EPPR-09-14

Access to OBD information

Japan's concept

Article4.2.3 [Amendment proposal 2]

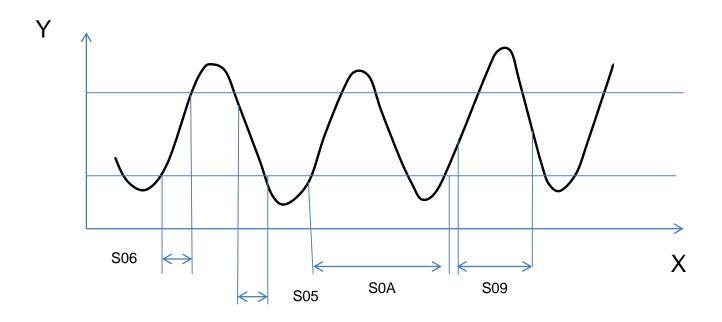
Reason:

The following are OBDII requirements

\$05 : Request oxygen sensor monitoring test results

\$06: Request on-board monitoring test results for

specific monitored (e.g. catalyst system)

Amendment: Delete texts below

- "In particular, a comprehensive explanation for the data in service \$ 05 Test
- =ID \$ 21 to FF and the data in service \$ 06 shall be provided. In the case of
- -vehicle types that use a communication link in accordance with ISO
- <u>—15765-4 'Road vehicles Diagnostics on Controller Area Network (CAN)</u>
- -Part 4: Requirements for emissions-related systems', a comprehensive
- explanation for the data in service \$ 06 Test ID \$ 00 to FF, for each OBD
- -monitor ID supported, shall be provided."

Example for where each data is monitored Judge the deterioration by monitoring the signal variation

<u>Information on Secondary Parameters</u>

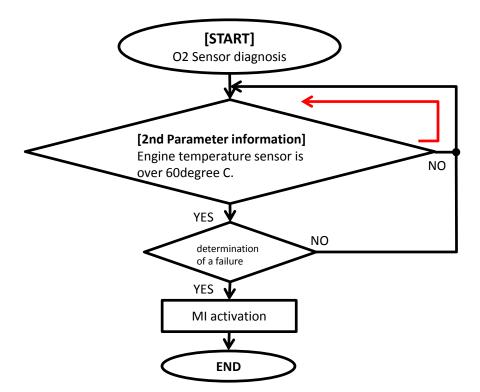
Information on Secondary Parameters is essential to achieve diagnostic function test.

Disclosure of the information on secondary parameters may give a chance to modify the control system unfairly, and then it may lead environment deterioration.

≪Concrete Example ≫

If oxygen sensor fail is detected, emission gas purification system is suspended. And then it lead environment deterioration.

Therefore MI activation is achieved by diagnosis flow chart as below.

One modification)

The oxygen sensor is removed when the muffler is exchanged to aftermarket one. Normally MI lamp is lit.

But if the sensor of engine temperature is modified not to reach 60 degree C when the temperature is over 60 degree C actually, there is no room for determination of oxygen sensor failure (looping the red directing arrow). Finally MI lamp is not lit.

This is a typical case of modification due to disclosure of the information on secondary parameters.
